## ASSESSMENT REPORT

### Central Park Concept Approval (MP 06\_0171 MOD 12) and Block 4N – Mixed Use Development (SSD 6673 MOD 1)

Figure 4: Proposed Public Domain Plan

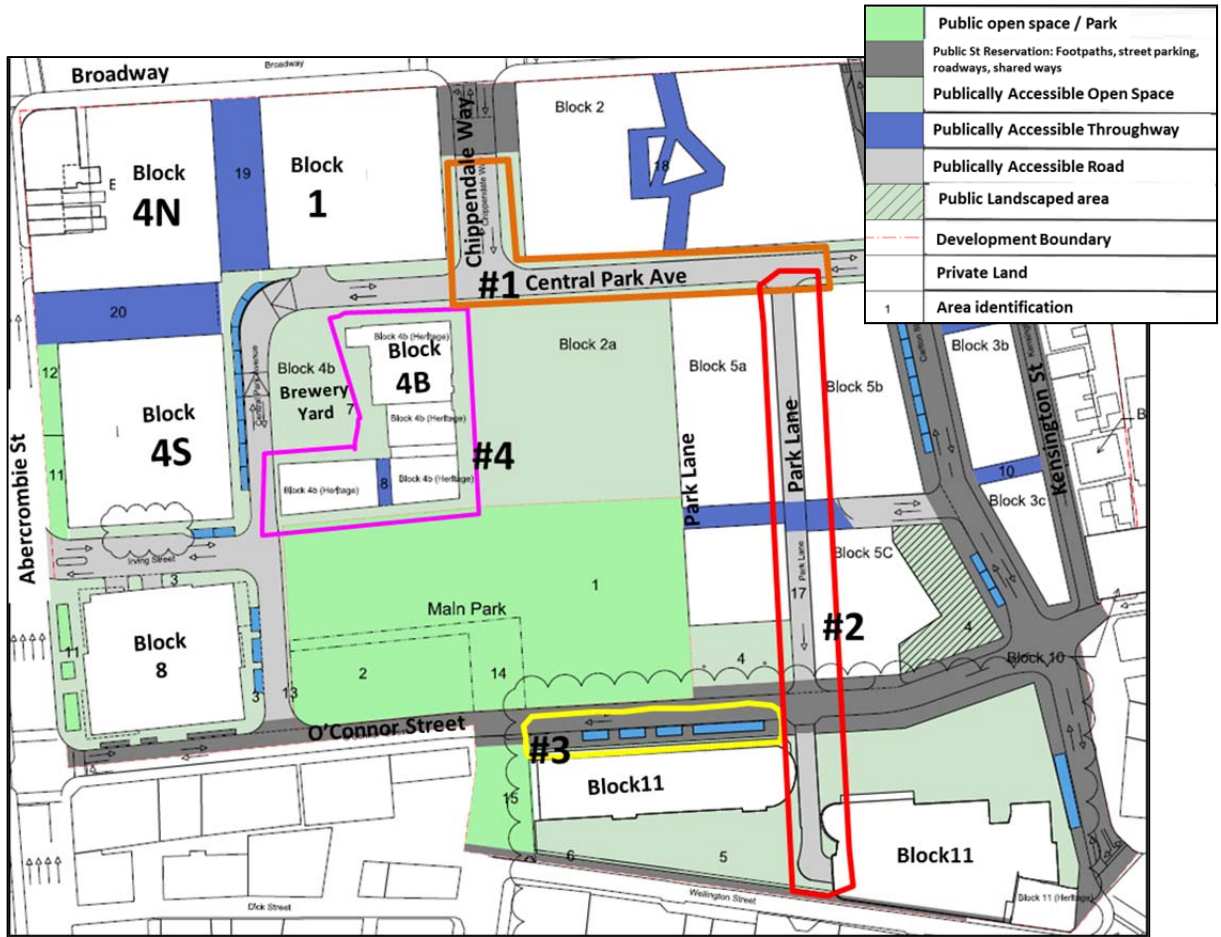
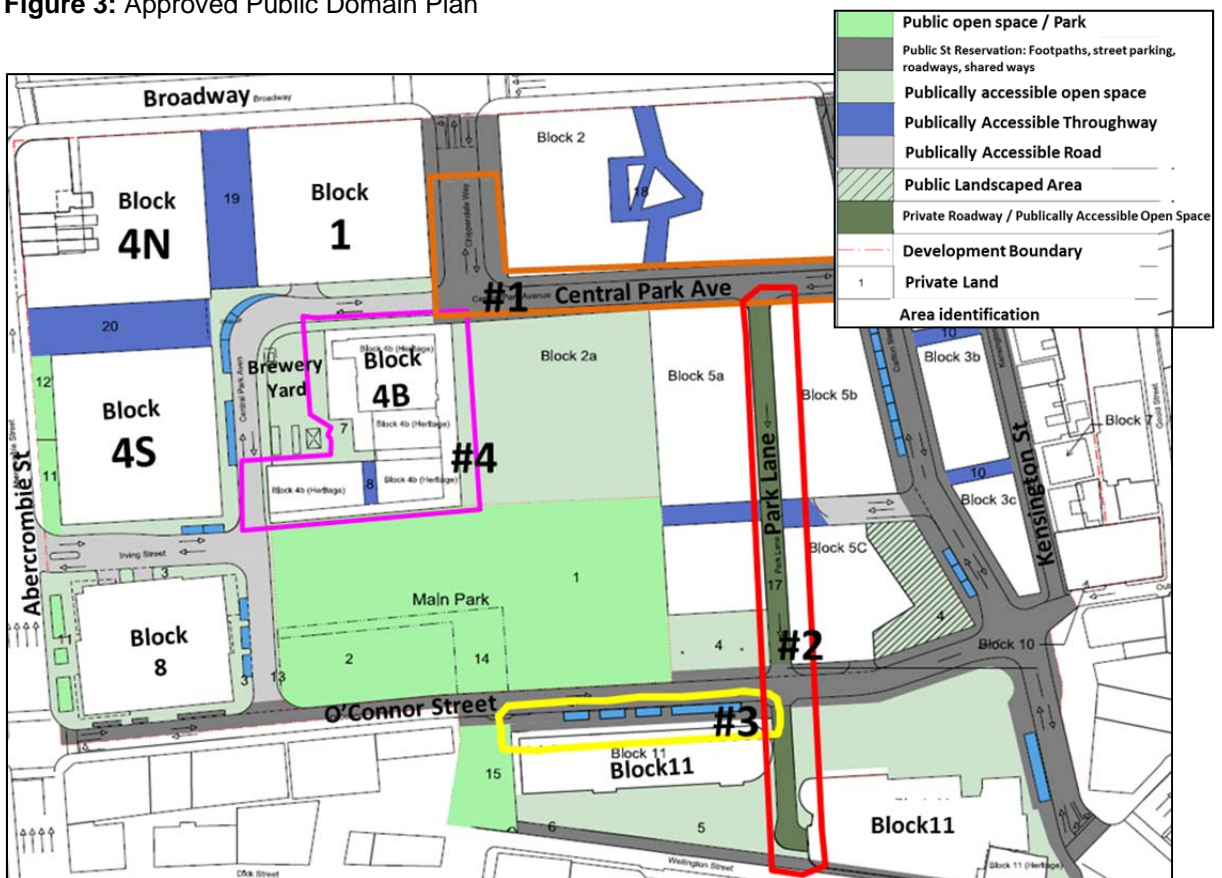
Park Lane and the access driveway to Block 11 (see **Figure 3 and 4**) is proposed to be retained in private ownership, and converted from a publically accessible 'street' to a private driveway that is publically accessible for pedestrians. Council raised no objection to this modification but notes that appropriate easements to ensure public access will be required. The Proponent has confirmed easements for public access will be implemented in each relevant project or development approval.

The modification seeks to amend the setback around the Block 4B brewery buildings (See area identified a No.4 in **Figures 3 and 4**). Currently the area up to the building line is identified as publically accessible open space. The Proponent seeks approval for part of the area around the building to be made private land.

The Department considers converting Park Lane from a publically accessible 'street' to a private driveway, that is publically accessible for pedestrians, is acceptable as the development would continue to provide sufficient vehicular access throughout the Central Park site. The Department also notes the Concept Plan approval includes a condition (Condition B4) which requires Rights of Way and Easements on title to ensure public access is provided and maintained.

The Department considers the proposed reduction in publically accessible land around Block 4B is a minor change and would not result in any material adverse impact, noting:

Figure 6: Approved and proposed layout of Ground floor with additional seating

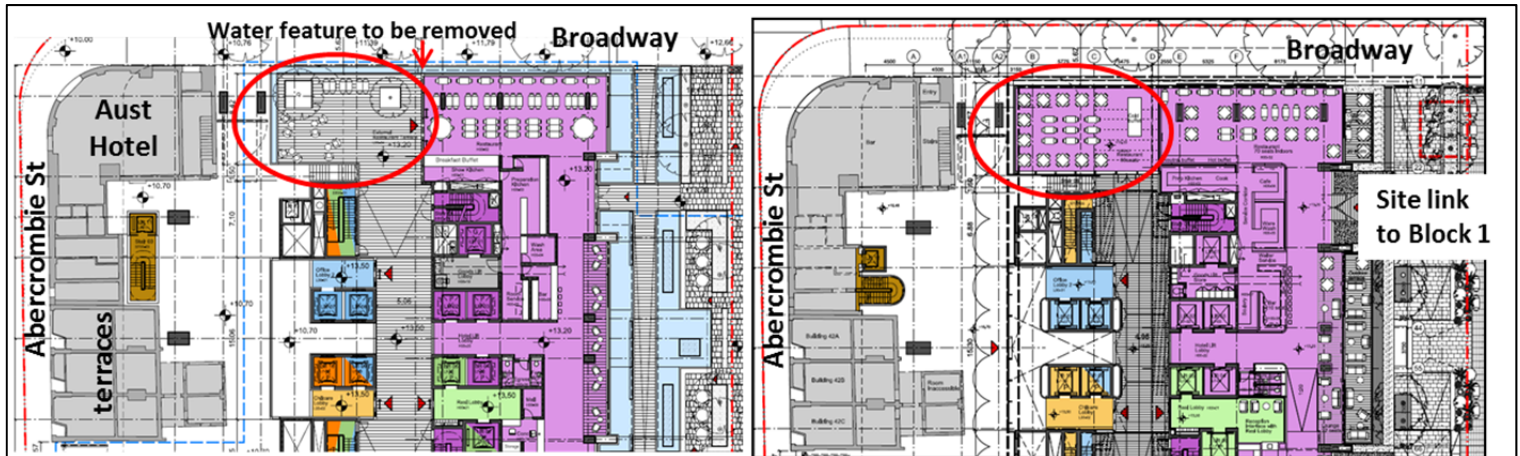
- The enclosure of the outdoor terrace at the Broadway frontage and changes to landscaping are not supported for reasons relating to: outdoor amenity; street activation; visual impacts and heritage impacts;
- Council does not support the additional signage zones on the north and west elevation;
- Consideration should be given to the impact of the internal changes to the communal hotel facilities on the amenity of the hotel; and
- Clarification was sought regarding the roof design changes and if changes were proposed to the residential section of the development.

<i>Enclosure of Outdoor Terrace</i>	<ul style="list-style-type: none"> <li>• The proposal seeks to enclose the outdoor restaurant and remove the landscaping and water feature from the ground floor of Block 4N fronting Broadway.</li> <li>• The Proponent advised the proposed change is sought to meet the amenity needs of the hotel and to respond to the context of the site facing Broadway.</li> <li>• Council does not support this aspect of the modification as it would result in:               <ul style="list-style-type: none"> <li>○ reduced street activation;</li> <li>○ loss of visual connection to the interior of the site;</li> <li>○ loss of a sense of open space between the development and the heritage listed Australian Hotel; and</li> <li>○ deletion of a canopy tree and loss of visual relief from the water feature.</li> </ul> </li> <li>• With regard to street activation, the Department acknowledges the approved terrace is unlikely to be highly utilised, due to its exposure to high traffic volumes along Broadway. The activation of this space is already comprised as the outdoor terrace cannot be directly accessed from Broadway.</li> <li>• Given these site constraints, the Department is satisfied the proposed enclosure of the terrace would not result in a significant loss or change to the activation of this part of the site.</li> <li>• With regard to the loss of visual connection into the site, the Department considers the void between Block 4N and the Australian Hotel would not be significantly impacted by the enclosure of the terrace as it is a single storey addition and the majority of the void space above the terrace would be retained.</li> </ul>	The Department recommends a new condition requiring amended plans of the Broadway Street elevation. .

<i>Issue</i>	<i>Consideration</i>	<i>Recommendation</i>
	<p>The Department also notes the enclosure would be constructed of glazing providing a light weight transparent structure, reducing its visual impact.</p> <ul style="list-style-type: none"> <li>• With regard to landscaping, the Department considers the proposed changes are minor and the proposal would still provide appropriate hard and soft landscaping to this part of the site.</li> <li>• The loss of the water feature from the Broadway frontage would expose a large expanse of blank wall to the street, reducing the design quality of this part of the development. Maintaining an appropriate level of design along Broadway is important as it is a key pedestrian thoroughfare into the southern part of the city. In addition, ensuring the development achieves design excellence is a key requirement of the Concept Plan approval. The Department has therefore included a new condition requiring amended plans to be submitted to demonstrate that an appropriate design is achieved for this elevation.</li> <li>• Overall, the Department is satisfied the enclosure of the terrace is acceptable and would not have a significant impact on street activation or any unacceptable visual impacts, subject to conditions.</li> </ul>

**Figure 11:** Approved and proposed site throughway

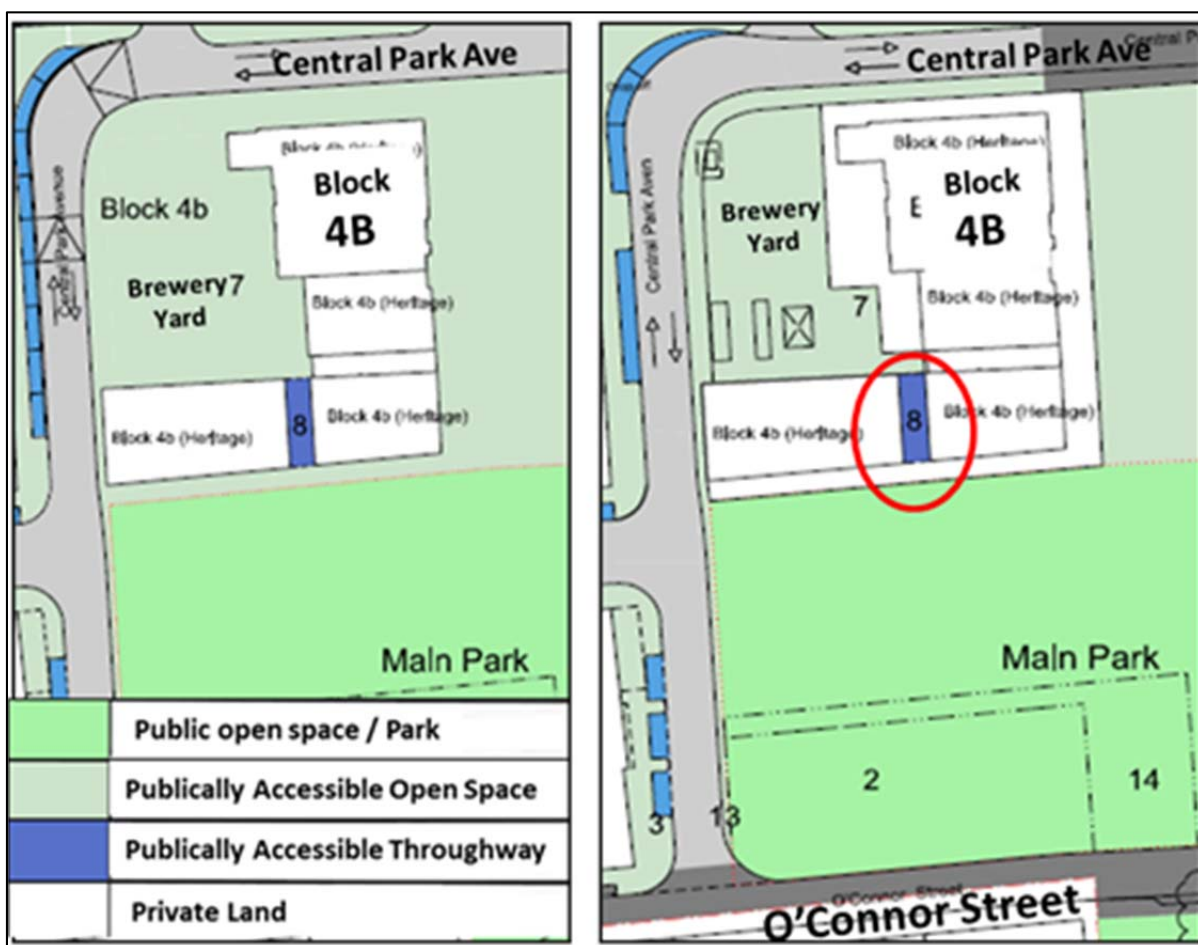
The Department also notes that the public domain plan requires the provision of a publically accessible through site link (see **Figure 11**). This link needs to be extended through the proposed 'private' southern curtilage (see highlighted in red below) to ensure it can operate effectively as a publically accessible thoroughway. A condition is therefore recommended requiring an updated public domain plan which illustrates the publically accessible thoroughway fully connects to the main park and not to privately owned land.
